Ancoats Mobility Hub

Ancoats Mobility Hub
Design and Access Statement Addendum
February 2023

This addendum document to the Design and Access Statement has been prepared by Buttress in conjunction with the professional team (listed to the right) to support a Minor Material Amendment application for the mixed use development known as the Mobility Hub.

The proposed development was granted planning approval on 30th July 2021 (Reference: 130627/FO/2021). Since this time Manchester City Council have appointed Bowmer and Kirkland as main contractor to deliver the scheme. The proposed amendments within this application have been developed in response to initial market testing on the delivery hub operator and construction supply chain, and initial building control advice.

Design Changes

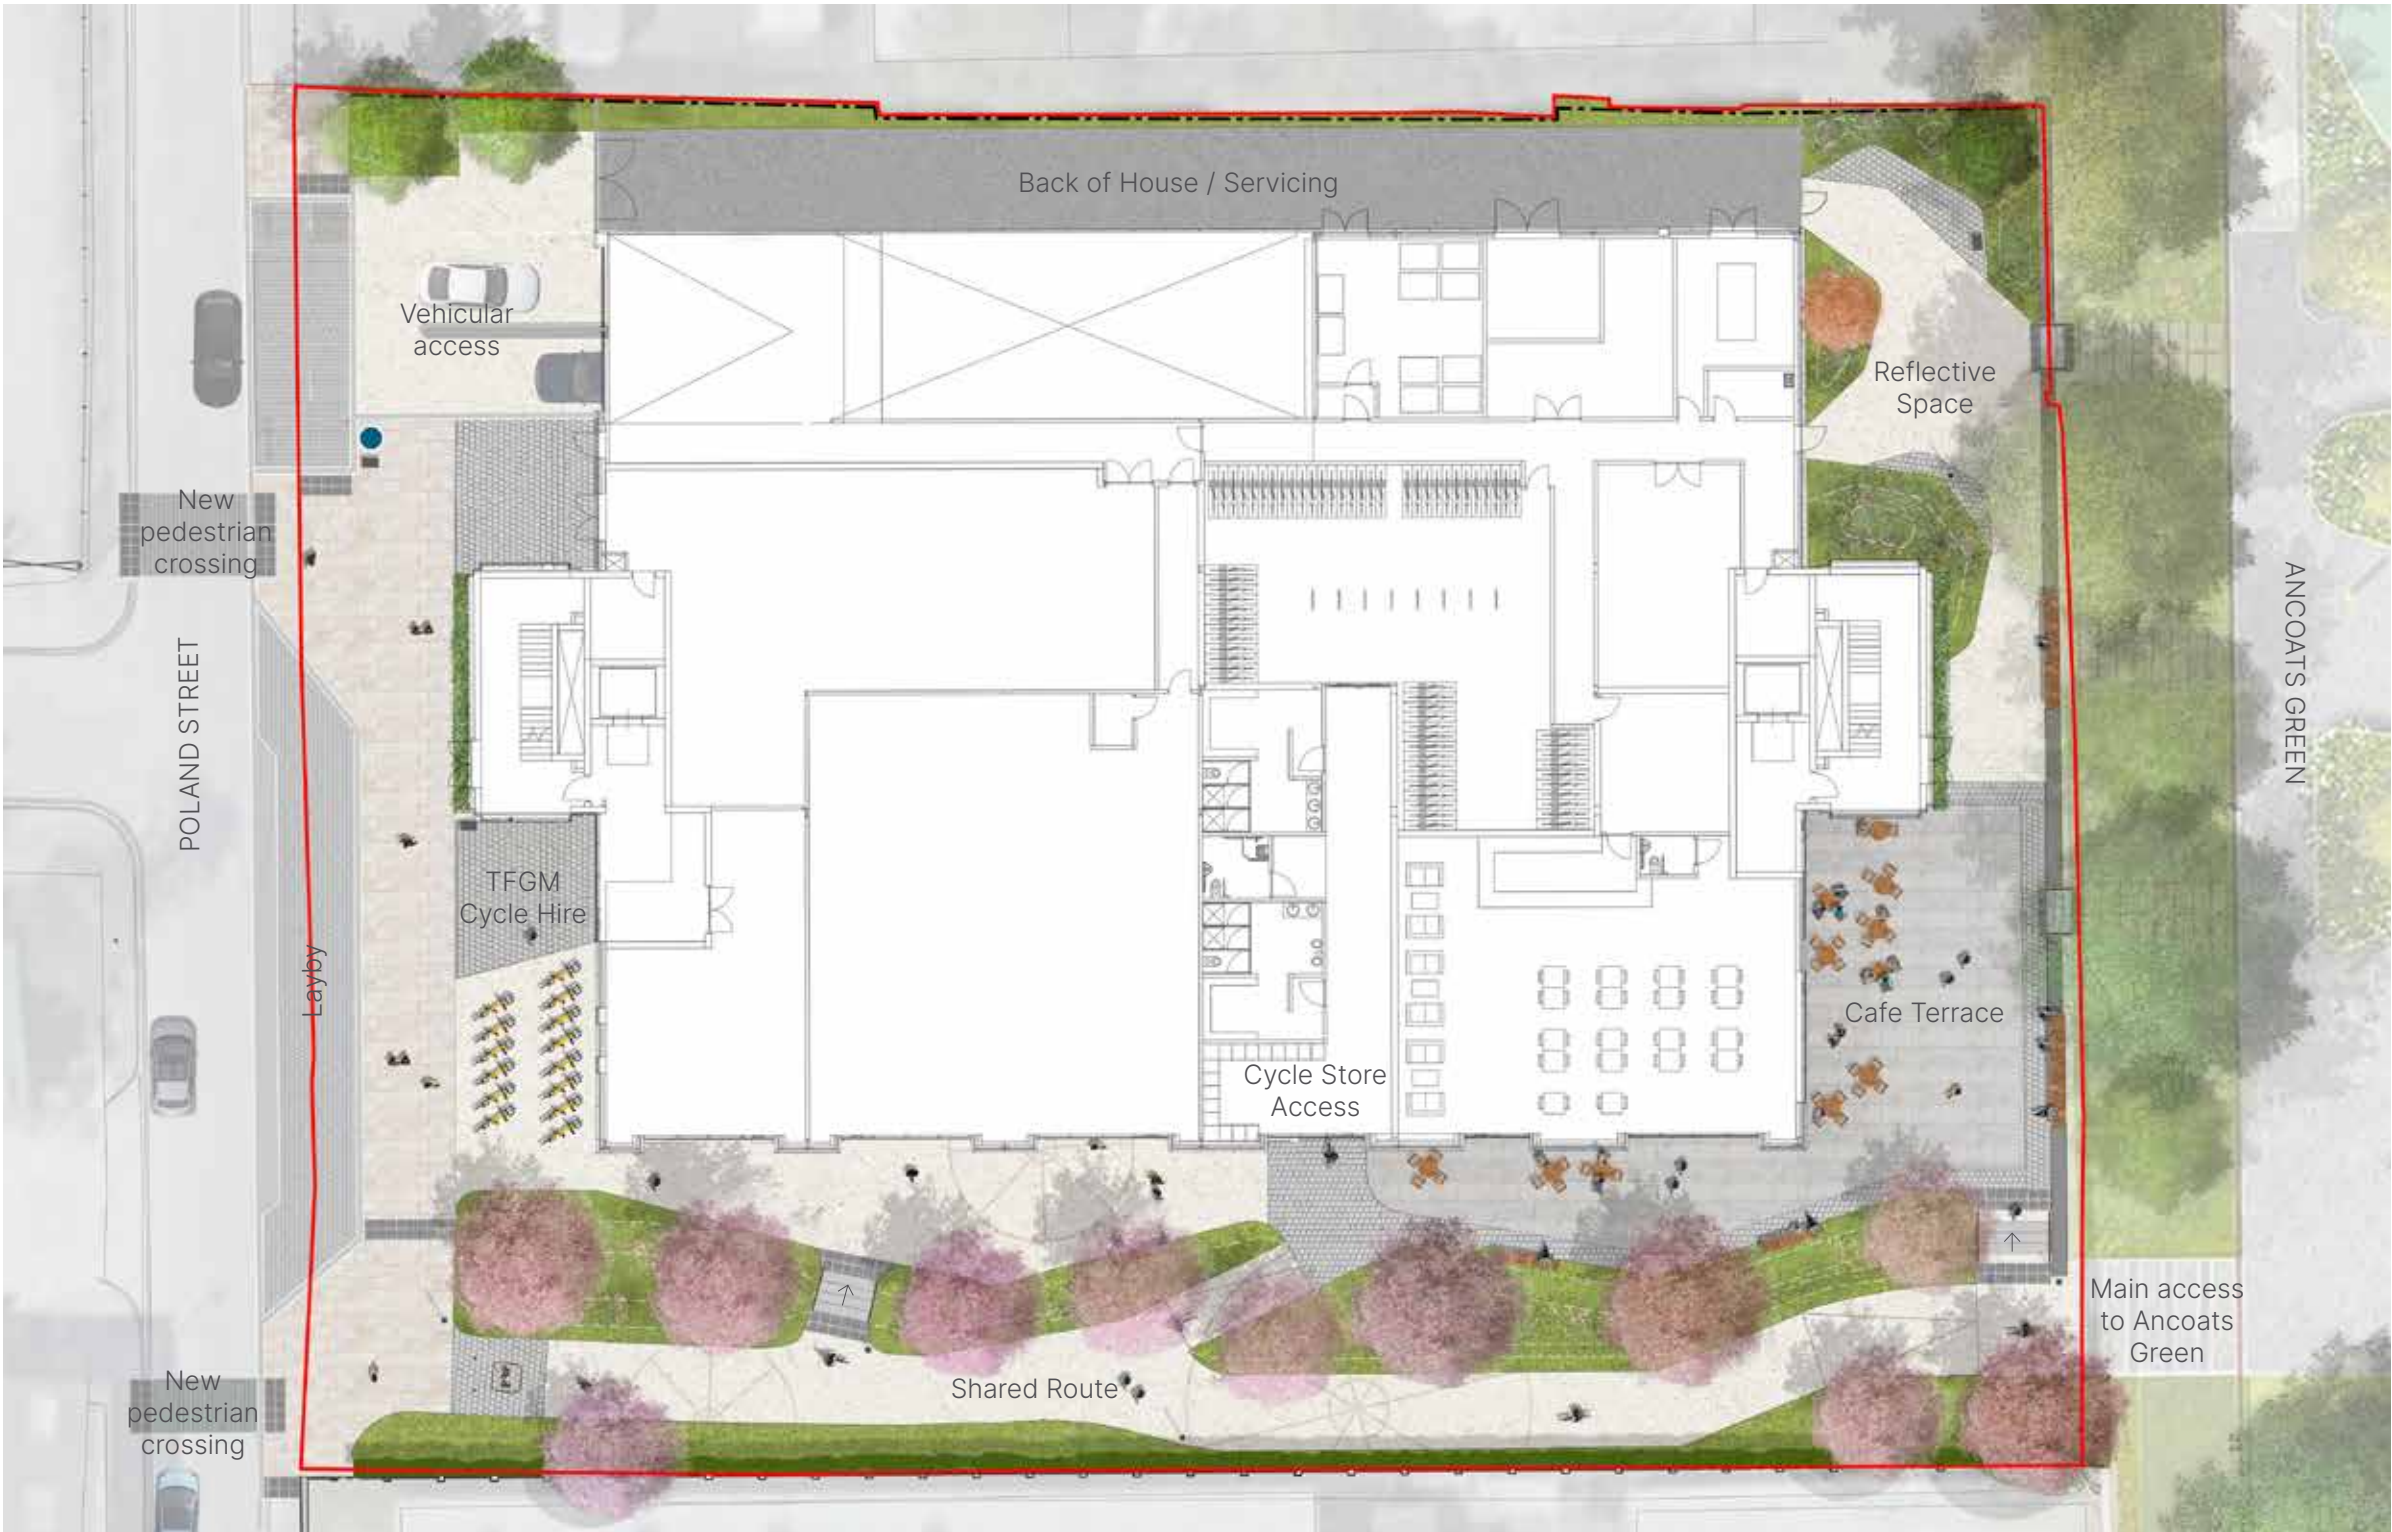
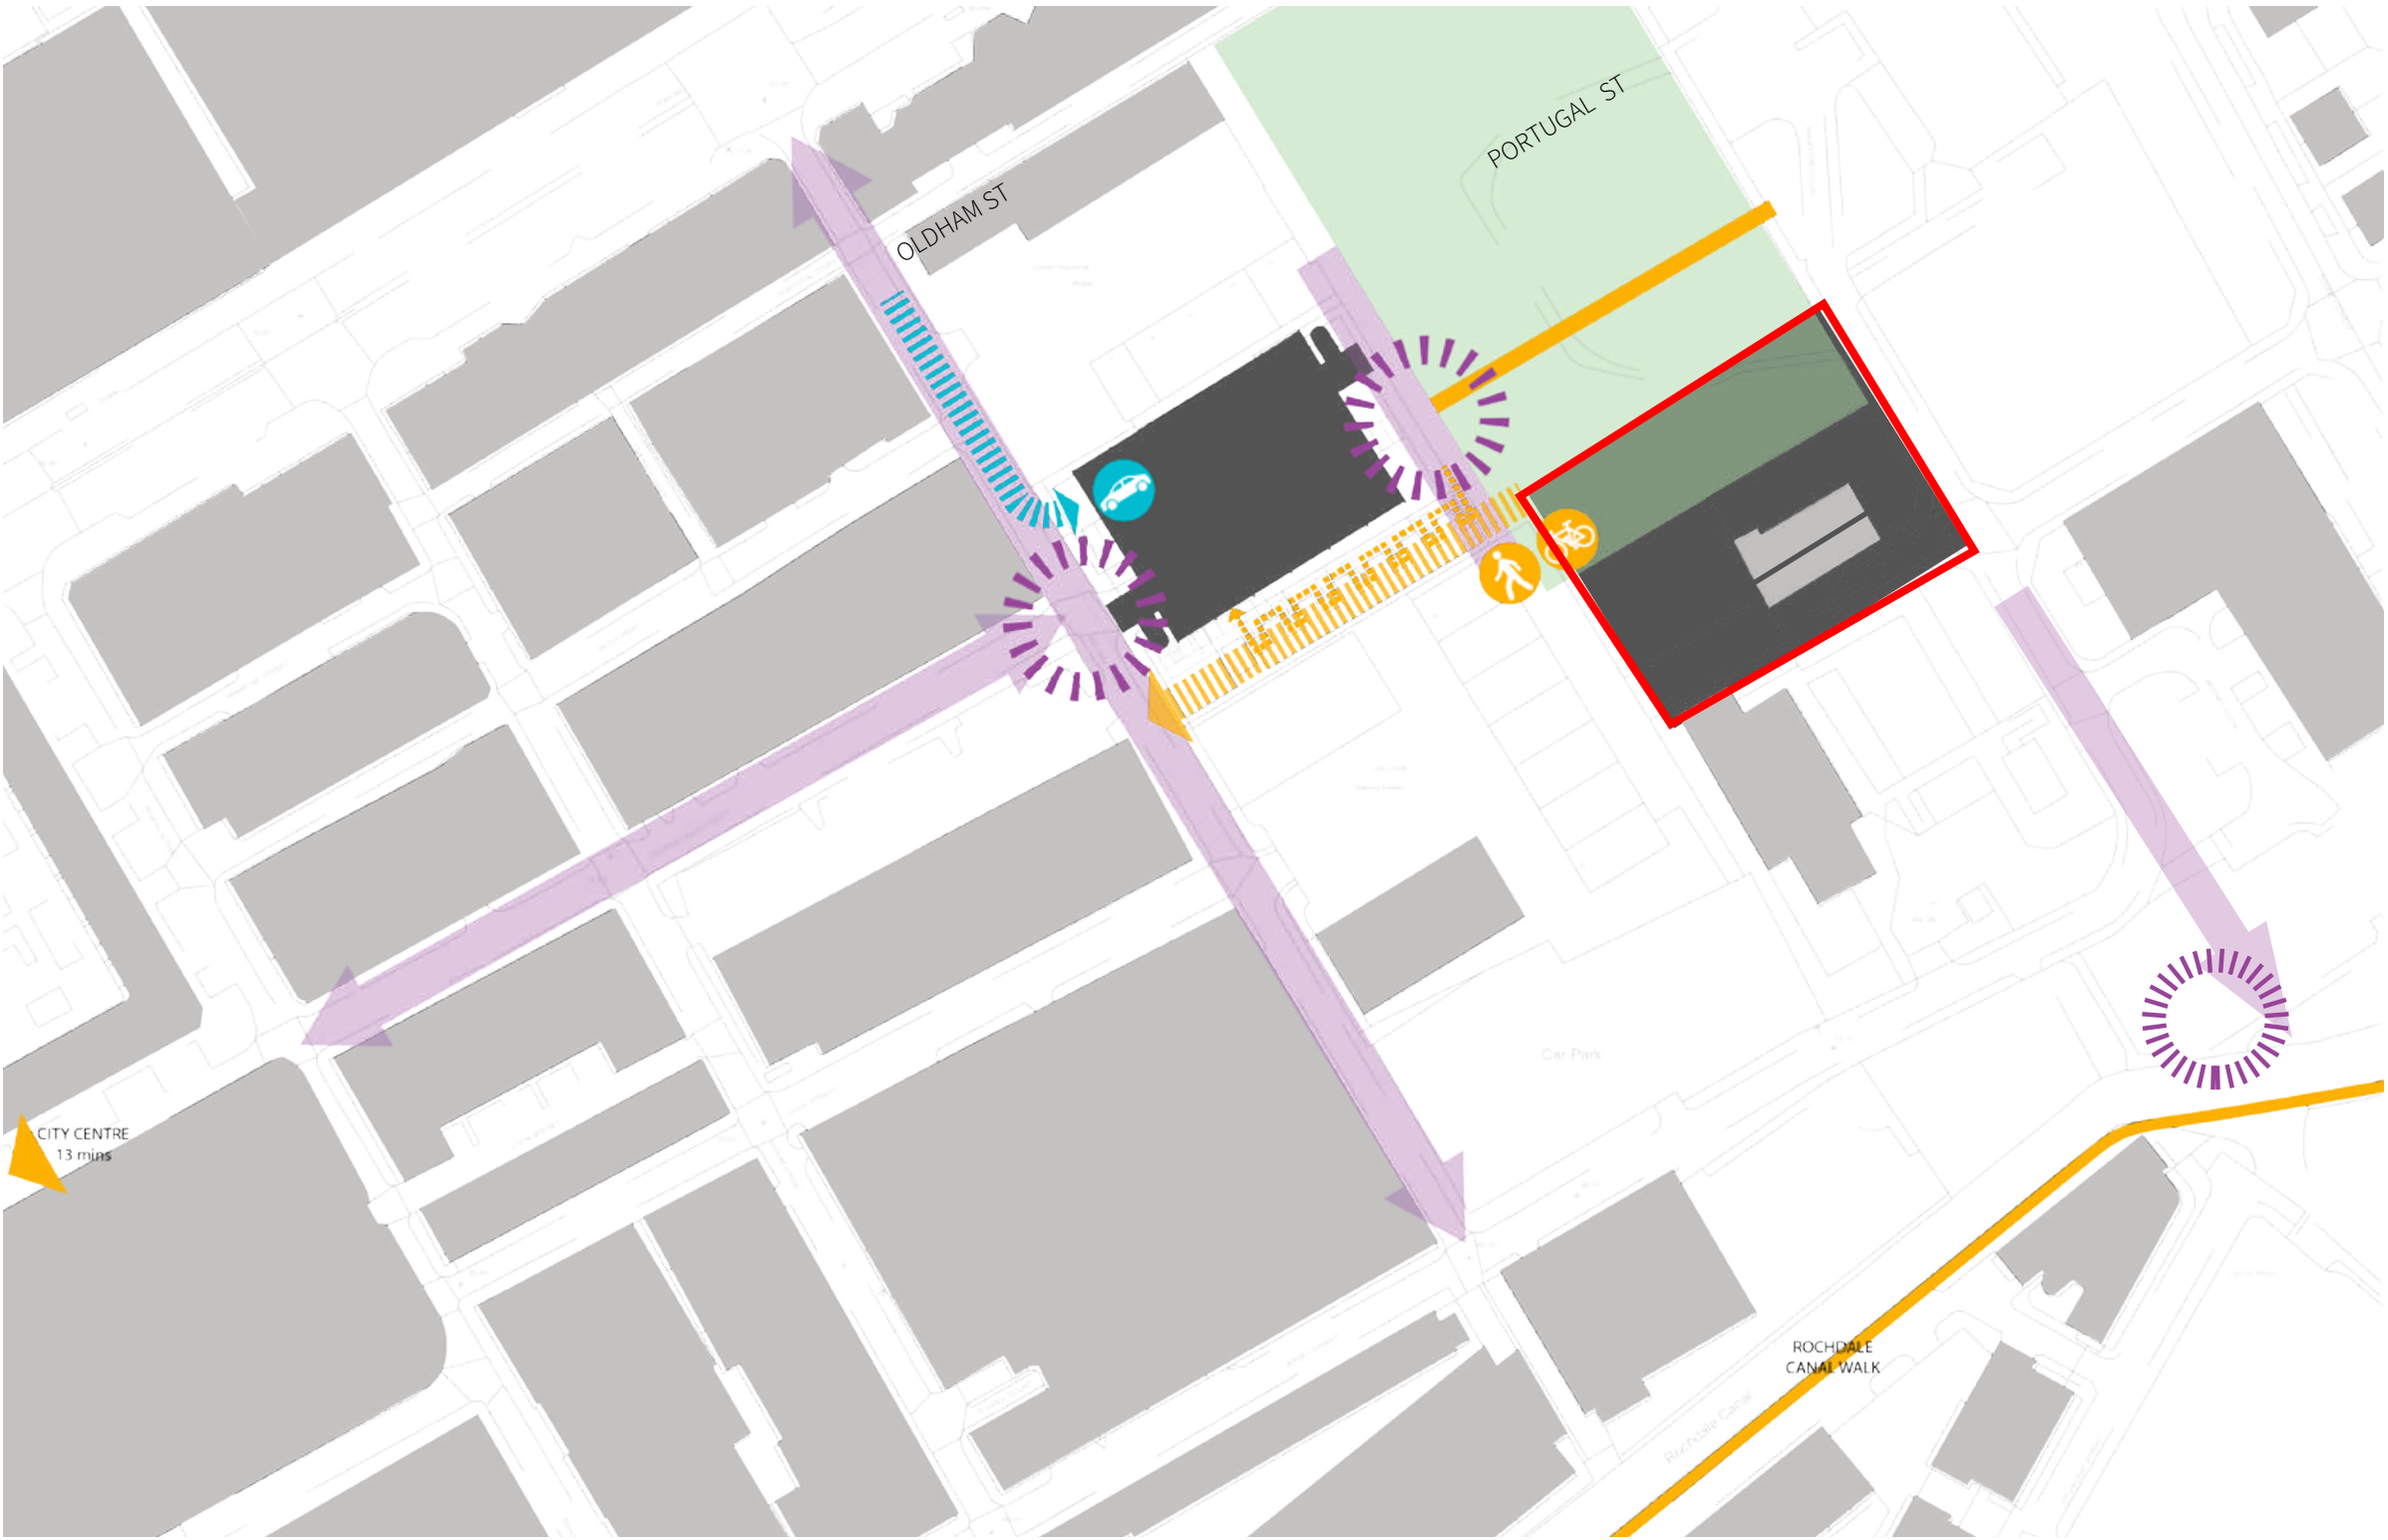
- Several changes have been made to the landscape design since the previous planning submission. The main reason owes to the updated architectural design, which includes changes to the ground floor functions / access. As a result the landscape has been updated to provide the necessary needs of the building for example flexible open space outside the F&B unit for spill-out opportunities, level access in the approach to the internal cycle storage and a secure line provided to the back of house servicing area.

- The shared cycle and pedestrian route and associated planters to the south of the site have also been revised to provide a more direct route from Poland Street to Ancoats Green, with a more generous clear width.

- Similarly the tree species have been revised to gives visual coherence with those proposed in Ancoats Green. Some trees have been relocated along Poland Street to make give the streetscape a greener and more welcoming feel.

- The planters have been reduced in height to sit flush with the adjacent paving. This enables opportunities for sustainable drainage, as any residual surface runoff from the hard landscaping can be collected in the planters - re-purposed as rain gardens.

- The layout associated with Poland Street has been updated including the introduction of a layby and pedestrian crossings. Since the previous submission, a wider public realm implementation strategy has been created which outlines design principles for streetscapes within Ancoats. The current design now adopts these principles to ensure consistency with the aspirations for the wider area.

- A gabion wall has been introduced to the interface with Ancoats Green. Since the previous submission design proposals for Ancoats Green have been developed sufficiently enough that greater design detail can be provided for the interface with the Mobility Hub scheme, this includes the main access threshold into the park and introduction of a gabion seating wall to take up the level difference whilst providing seating opportunities.
